**Exception Request No.: 130**  
**Section: SHEB**  
**Town: Easton**  
**Highway: NH 116 (Tier 3)**  
**Station: 656+25 to 669+75**  
**Drawing No.: SHEB C159 to C161**  
**Survey Report Cross Reference No.: SHEB C157 to C158**  
**Exception Type: Alignment in Pavement**  
**Splice Enclosure in Pavement**  
**Road Crossing**

NPT is requesting an exception from the UAM guidelines for the location of the cable trench in the pavement on NH 116, Easton Road from station 656+25 to 669+75 of the NPT SHEB Underground Alignment.

EXCEPTION 130-ALIGNMENT IN PAVEMENT  
NPT SHEB-UNDERGROUND ALIGNMENT  
SHEB SECTION STA 656+25 TO 669+75  
SCALE: H. 1"=30', V. 1"=10'  
DATE: 12/12/2016

DES: TDD  
CHK: MRR  
DRW: TDD  
APR: TMH  
TOWN: EASTON  
TRANSMISSION LINE: SHEB  
EXHIBIT A.1

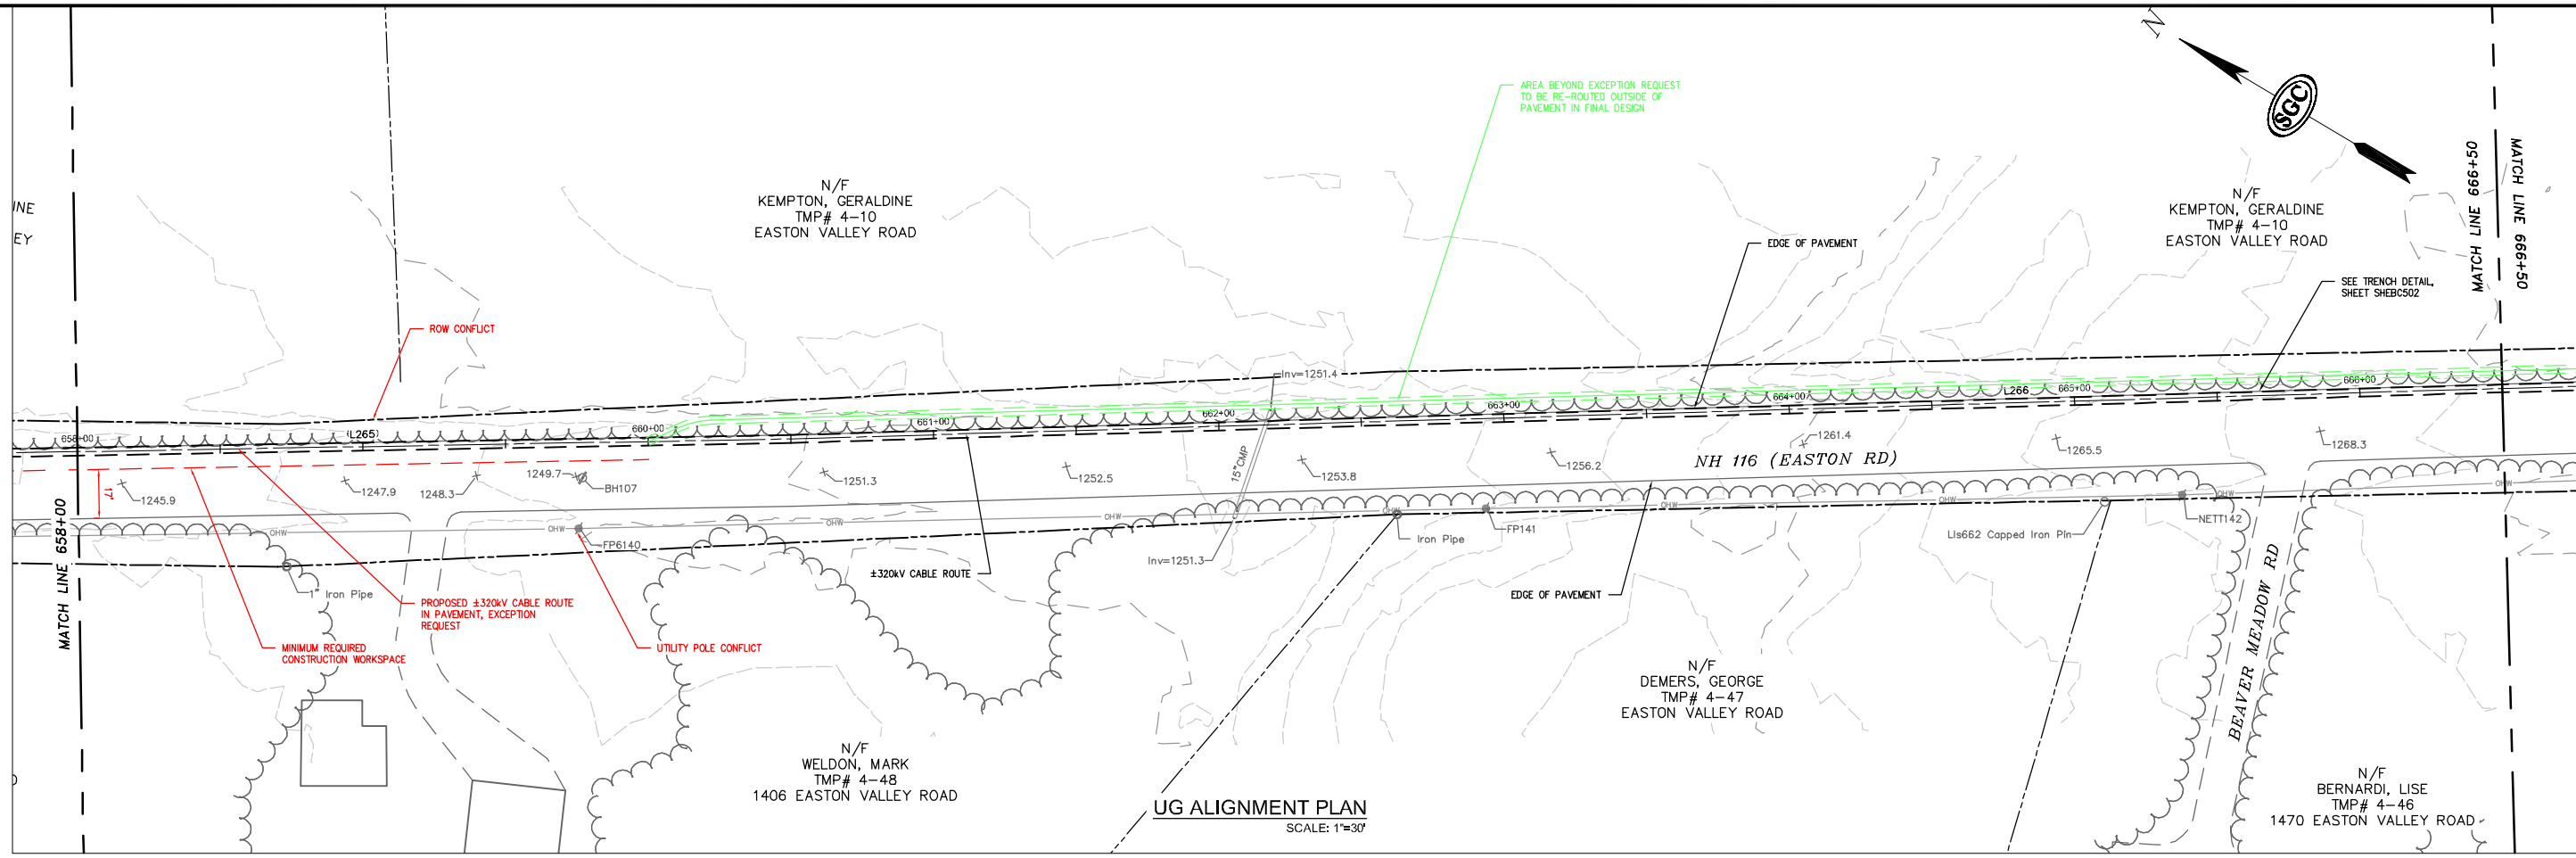
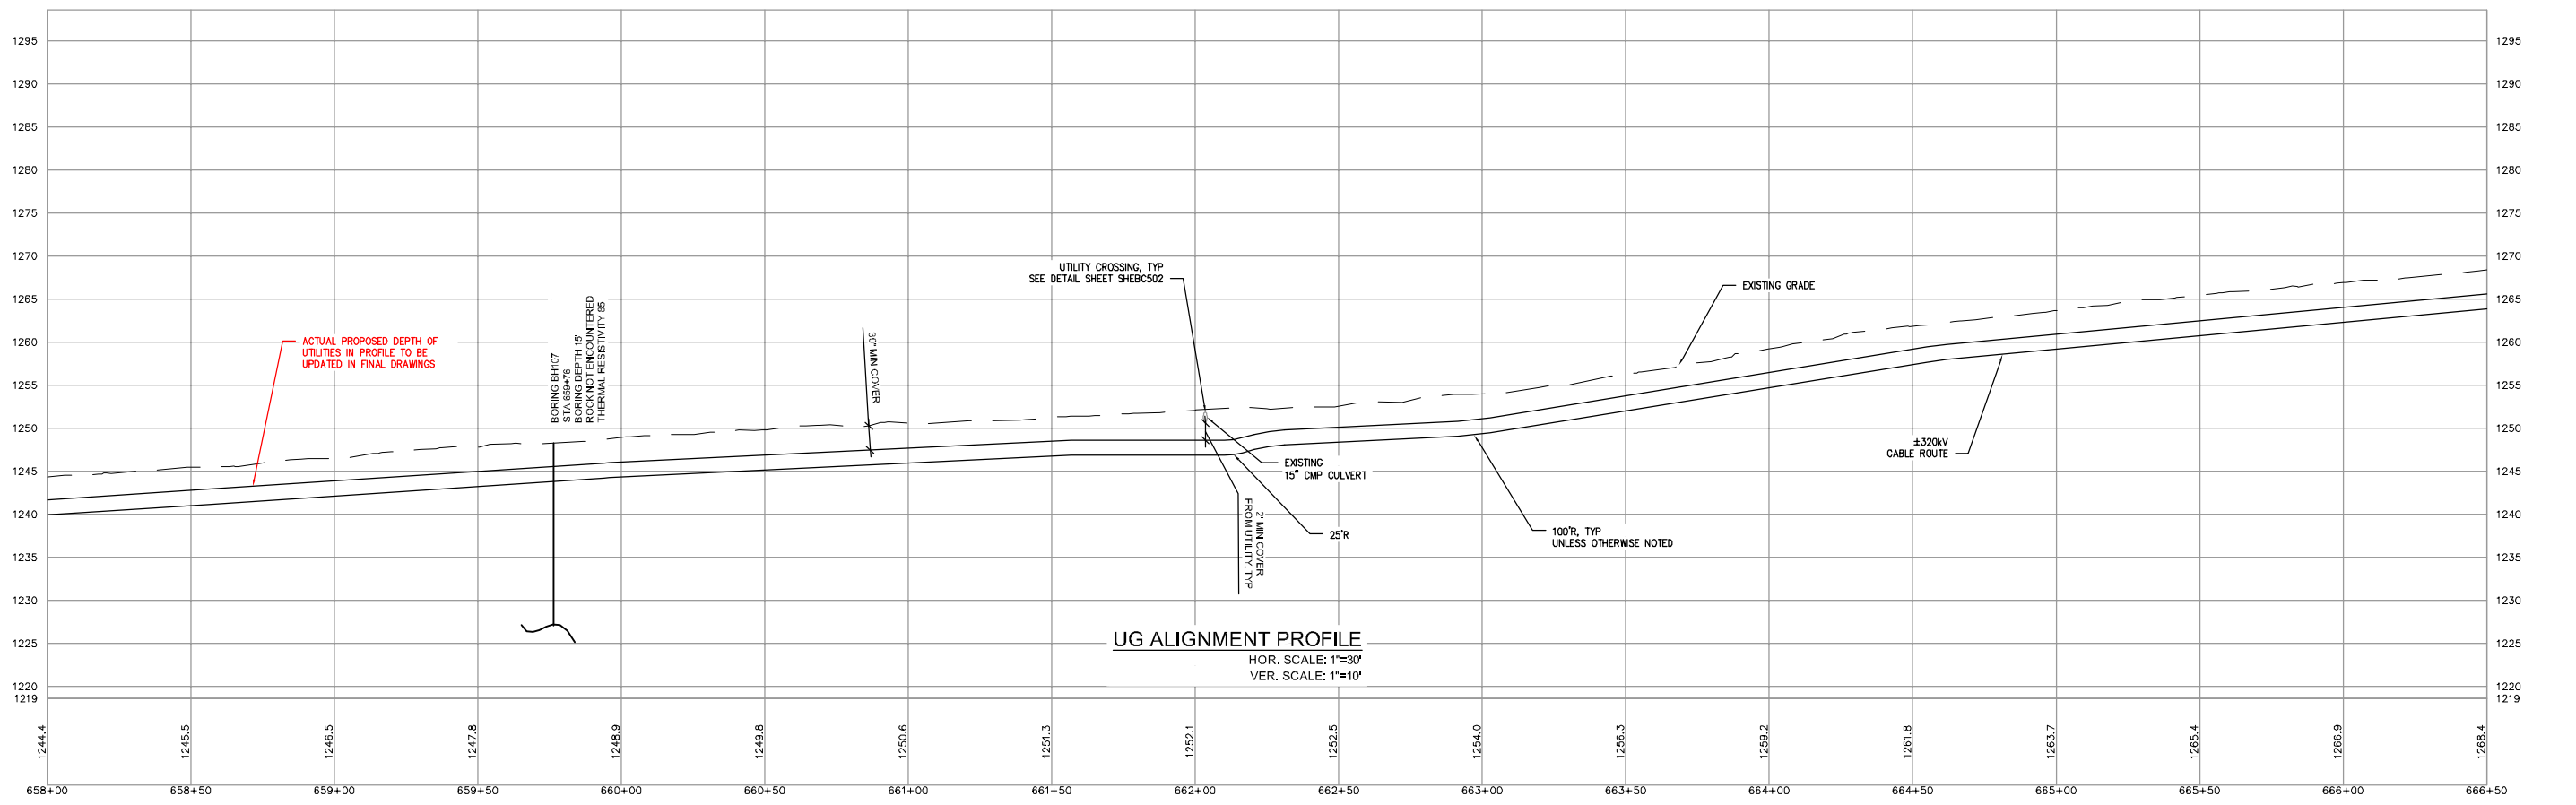
The roadway alignment at this location is constrained by a narrow ROW on the eastern side of NH 116. Installation of the cable trench outside the paved area would require additional rights on private property outside the NHDOT ROW. The ductbank has been re-routed out of the pavement to the maximum extent.

Due to limited space between the edge of pavement and the limits of the NHDOT ROW the duct bank will be located within the pavement or partially in the pavement from approximately 656+25 to 660+00.

NPT also evaluated placing the cable trench alignment on the western side of the road in this area, however similar to the east side the limited space plus the presence of the overhead utility line does not allow sufficient space for construction of the duct bank outside of the pavement. Due to the limited space, relocation of utility will not provide the space required.

In addition, the alignment will enter the pavement from approximately 669+00 to 669+75 to accommodate a road crossing. The road crossing at 669+00 is proposed to avoid the limited space between the edge of pavement and the limits of the NHDOT ROW that begin at approximately 670+00, as well as the overhead distribution line that also transitions to the east side of the road at that location. The road crossing is located to maximize the amount of the duct bank that is located outside the pavement.

Note: NPT is requesting an exception for the portion of the alignment from station 656+25 to 660+00 and 669+00 to 669+75. In the original permit drawings, NPT proposed an alignment within the pavement for a longer portion of the roadway in this area. In response to NHDOT comments, NPT has reduced the length of the alignment within the paved area by approximately 1200 feet in this area. The revised alignment will be reflected in revised drawings to be submitted at a later date.

**TITLE:**  
EXCEPTION 130  
SPLICE ENCLOSURE IN PAVEMENT  
NPT-SHEB UNDERGROUND ALIGNMENT  
SHEB SECTION-STA 656+50±  
TOWN: EASTON

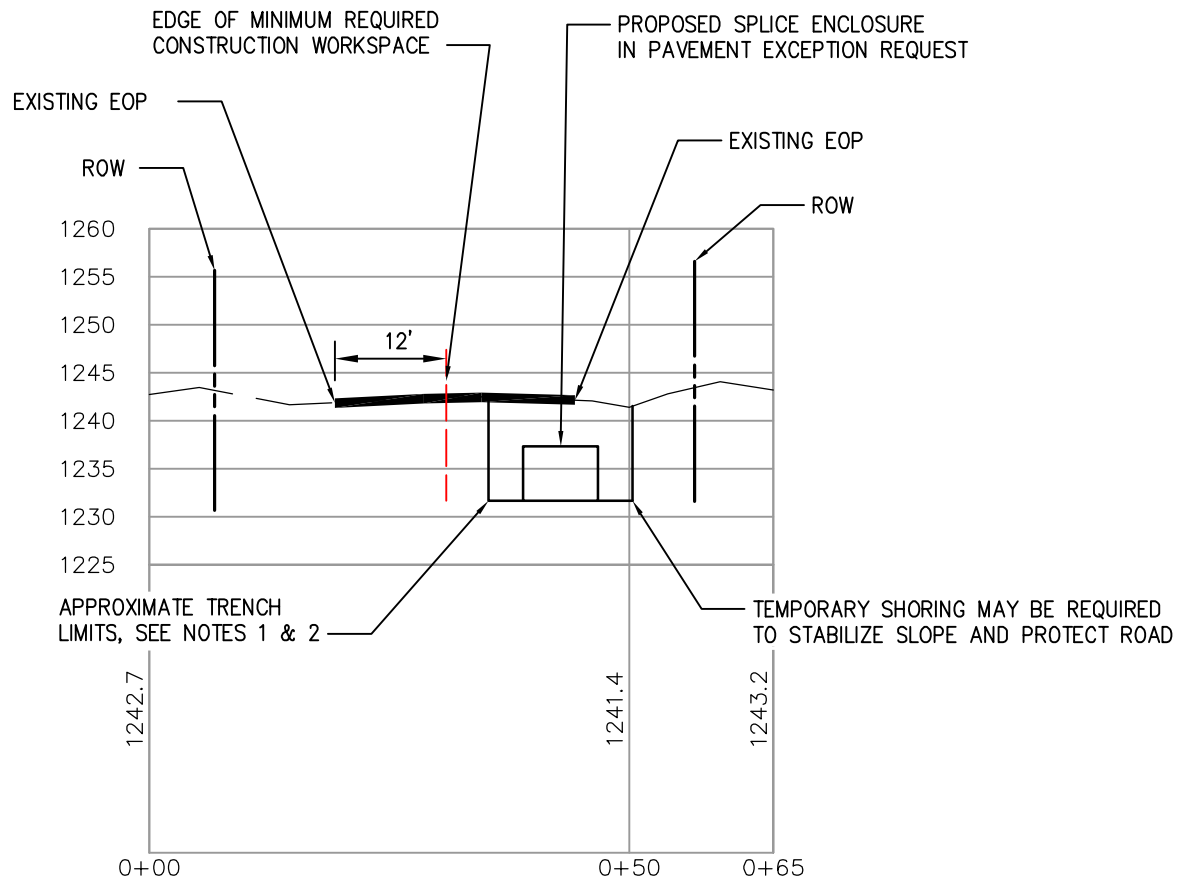
In addition, our exception request in this area includes a splice enclosure in the pavement at station 656+50. The proposed location of the splice enclosure is set back from edge of the ROW to allow for the needed construction work space. (See Exhibit B.)

To construct the splice enclosure, a minimum 10-foot work area is required on all sides. At the location of this splice enclosure, the narrow ROW prohibits construction outside the pavement within the ROW.

The location of each splice enclosure along the alignment is constrained by the maximum cable reel length of 2,100 feet. The limited ROW width constraining the enclosure's location extends over 2,100 feet in this area. This distance will require that a splice enclosure be located within the pavement in this section.

NPT evaluated options for moving the splice enclosures to the opposite side of the road (west) and along the alignment, but the same space constraints exist on both sides of the road.
